Project	IEEE 802.16 Broadband Wireless Access Working Group < http://ieee802.org/16 >	
Title	Technical and editorial amendment of 802.16-2004 facilitating license-exempt and uncoordinated band operation	
Date Submitted	2006-01-11	
Source(s)	Paul Piggini Cygnus Communications 2075 Las Palmas Drive Carlsbad CA 92009	Voice: 760 448 1984 Fax: 760 448 1989 ppiggin [at] cygnuscom.com
Re:	Call for Contributions, IEEE 802.16h Task Group on License-Exempt Coexistence, IEEE 802.16h-05/023	
Abstract	This document contains suggested amendments to the working draft and base standard to facilitate a framework from which MAC enhancements for license-exempt and uncoordinated system operation can be developed.	
Purpose		
Notice	This document has been prepared to assist IEEE 802.16. It is offered as a basis for discussion and is not binding on the contributing individual(s) or organization(s). The material in this document is subject to change in form and content after further study. The contributor(s) reserve(s) the right to add, amend or withdraw material contained herein.

Technical and editorial amendment of 802.16-2004 facilitating license-exempt and uncoordinated band operation

Figure xyz Representation of 'Channel Centre Frequency' calculation.

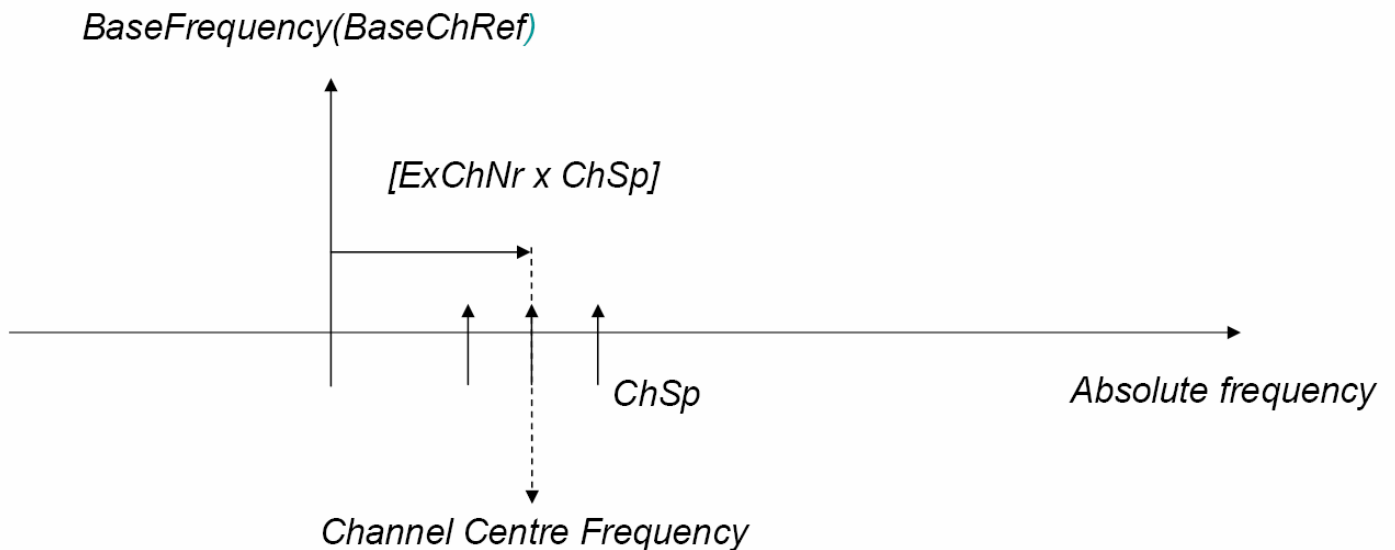
In summary the definition of the *Channel Centre Frequency* is:

$$\text{Channel Centre Frequency [MHz]} = \text{BaseFrequency}(\text{BaseChRef})[\text{MHz}] + (\text{ExChNr}[\text{MHz}] * \text{ChSp} [0.01\text{MHz} + 10\text{kHz}]) \quad [\text{xxx}]$$

This is shown in a graphical representation in figures [xyz].

Figure 219—Illustration of OFDMA frame with multiple zones

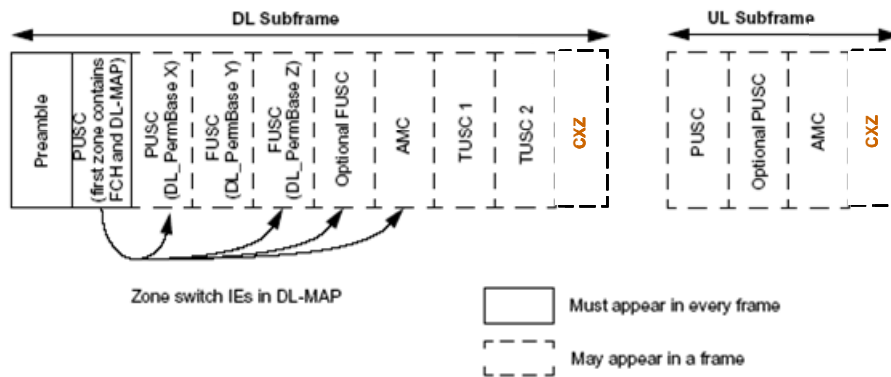
In support of the material added in section 6.4.2 make the following changes to the OFDMA PHY specification in figure 219 in section 8.4.4.2.

The OFDMA frame may include multiple zones (such as PUSC, FUSC, PUSC with all subchannels, optional FUSC, and AMC, CXZ, TUSC1, and TUSC2), the transition between zones is indicated in the DL-Map by the STC_DL_Zone IE (see 8.4.5.3.4), CXZ_DL_IE (see 8.4.5.3.11), or AAS_DL_IE (see 8.4.5.3.3). No DL-MAP or UL-MAP allocations can span over multiple zones. Figure 219 depicts the OFDMA frame with multiple zones.
